**Resolution to the current challenge of not meeting National Environmental Policy Act requirements and Historical Resources 4 (f) requirements.**

DEIS

Citizen Comment

## Port of Vancouver Freight Corridor Travel Time Study Concerning Increased Congestion and Delay Because of CRC High Capacity Transit

**Figure 4**  
Existing and Future Eastbound Travel Times by Route - No High Capacity Transit

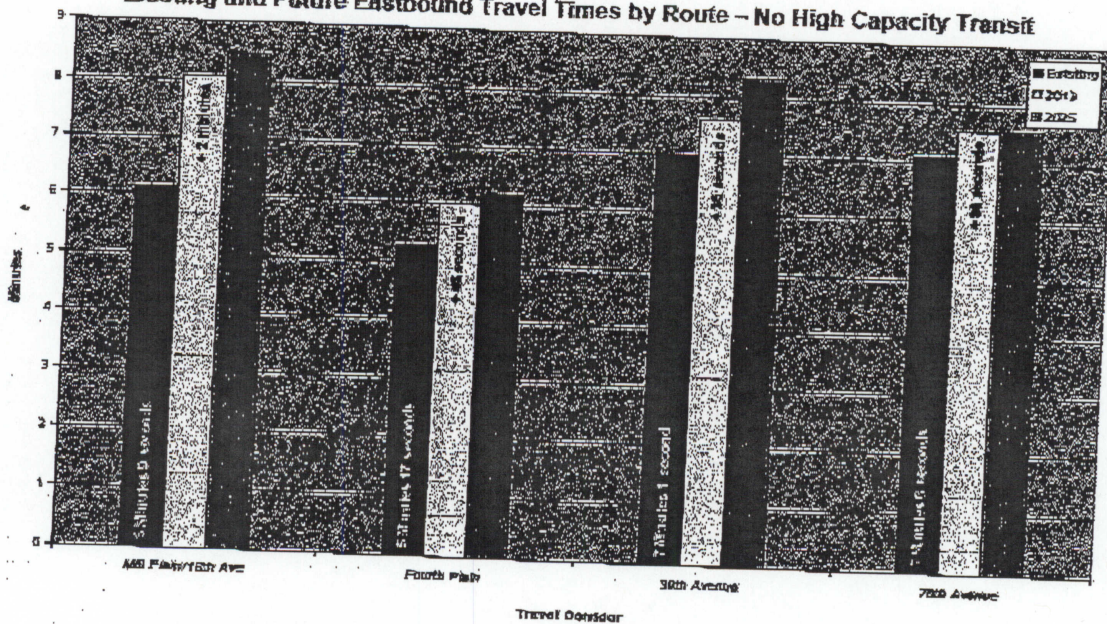
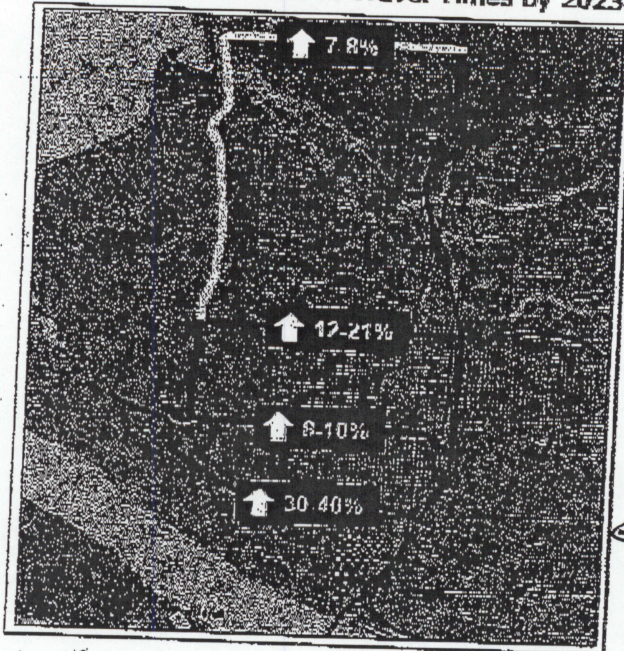
3. This report doe not include single trips and other data. Mill Plain goes up by 40% yet does not include commerce or commuter traffic.
4. Further data analysis may demonstrate addition impacts to freight movement. Old data was used when the NEPA process requires CRC to provide new data and numbers.

③ will 40%  
← does not include commuters  
commerce or  
Signal Priority
